MEMORANDUM

SUBJECT: FP23-04 – 6050 Belt Line

PROJECT: DWU22105 - Dallas Floodplain Reviews

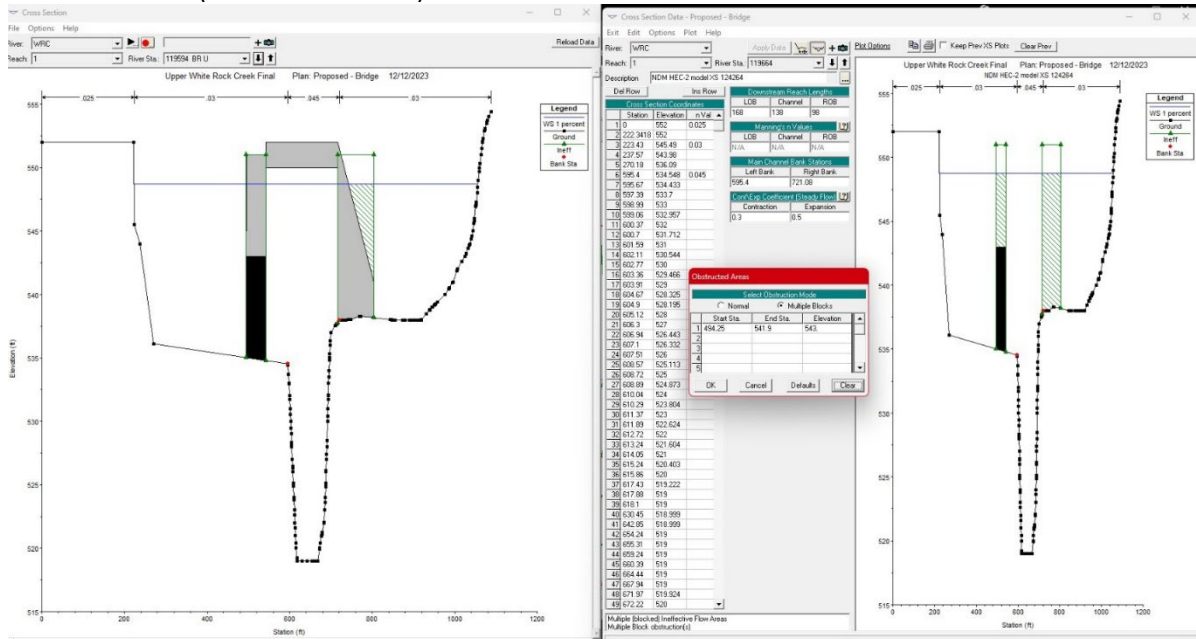
- In the proposed conditions model for the scenario without a bridge, cross section 119591 (referenced below) was eliminated. This was done to ensure that there were no negative alterations between the revised existing and proposed conditions results, in the event that the proposed grading for the pedestrian bridge is excluded.

- In the proposed conditions scenario that includes a pedestrian bridge, the blocked obstruction at cross section 119664 (referenced below) was eliminated. The outcome remained the same.
